**PLANNING & ZONING BOARD
AGENDA ITEM 6A**

TOPIC: **PUBLIC HEARING** for Otter Crossing South Preliminary Plat and ALDI Site and Building Plan Review

To: Katie Larsen, Lino Lakes City Planner
From: Diane Hankee PE, Lino Lakes City Engineer
Date: March 5, 2025
Re: Otter Crossing South
Preliminary Plat Review
028173-000

To: Katie Larsen, Lino Lakes City Planner
From: Diane Hankee PE, Lino Lakes City Engineer
Date: March 5, 2025
Re: Aldi Store #154
Site Plan Review
028170-000

SITE PLAN

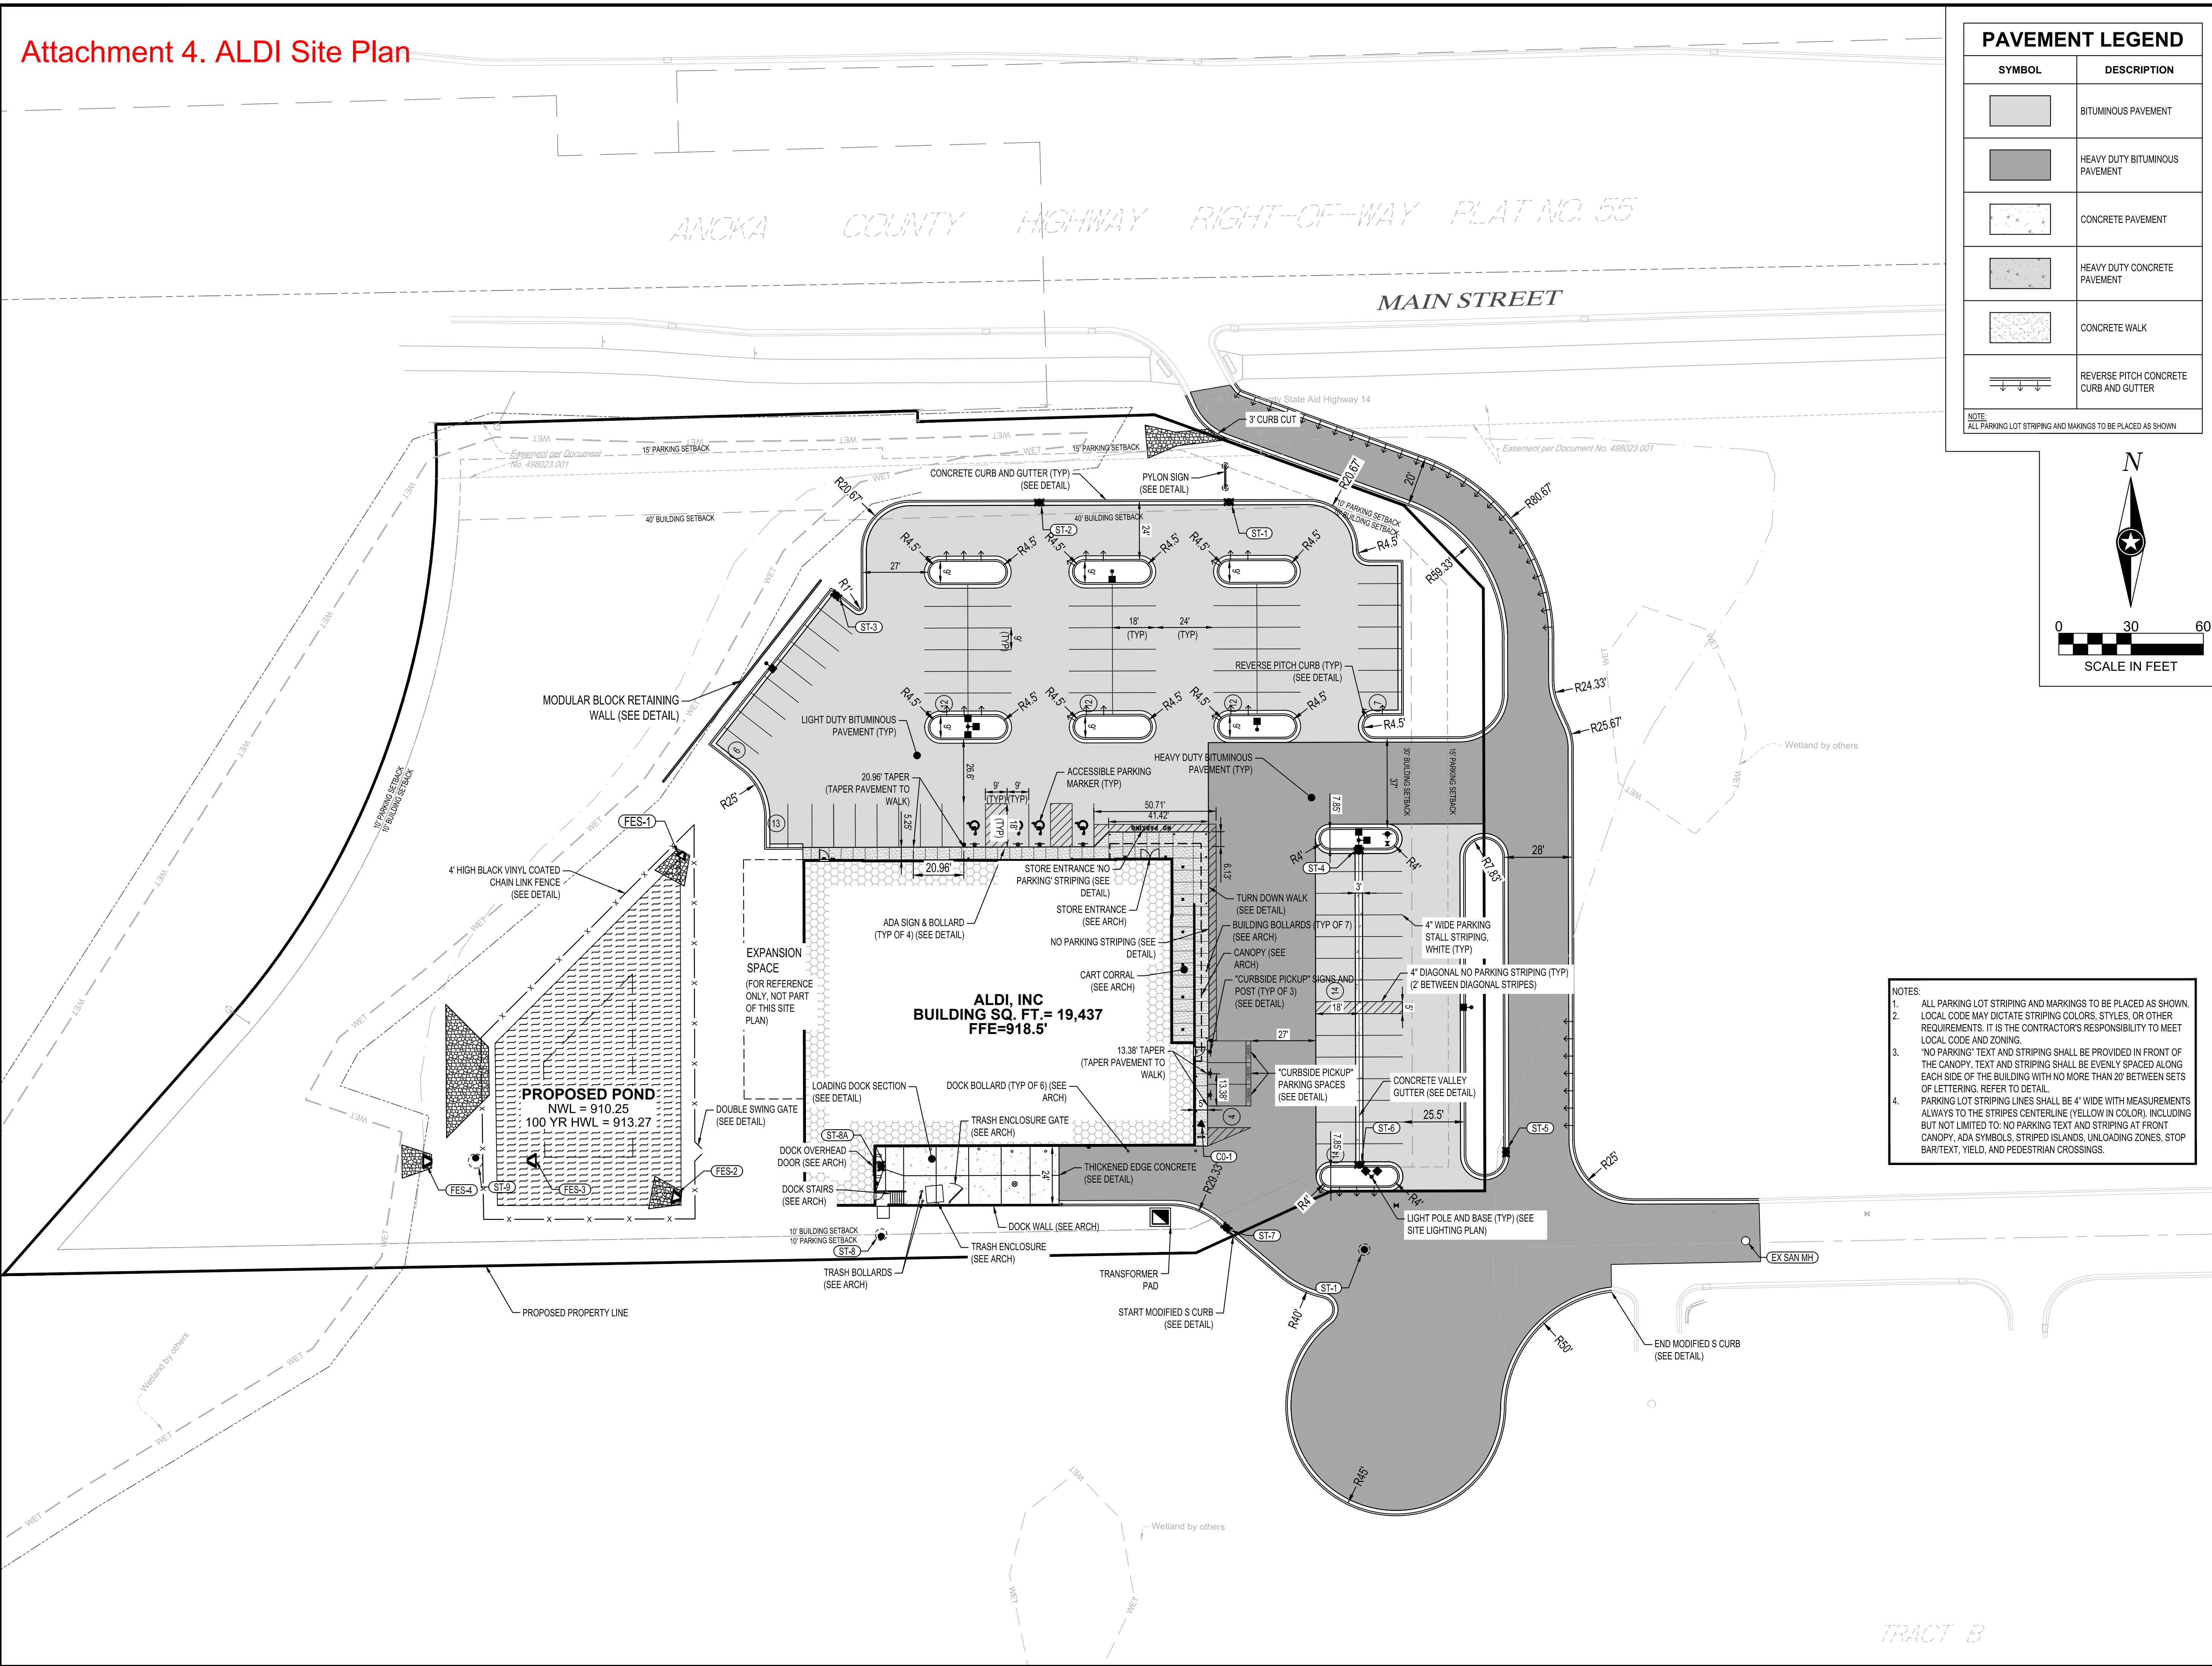
16. Sheet C-310, Site Plan:
- a. Label all lines on the plan sheet. For example, there are unlabeled lines to the west of the parking lot near the wetland.

- b. The fence around the stormwater pond shall be omitted.
 - c. The 37 ft wide northerly driveway shall be revised to 36 ft maximum.
 - d. Sidewalk shall be included along the private streets from Main Street and Otter Lake Drive.

- g. The dock wall shall be high enough to screen the trash enclosure.
17. Sheet C-320, Site Utility Plan:
- a. The FDC shall be located in the northeast corner of the building.
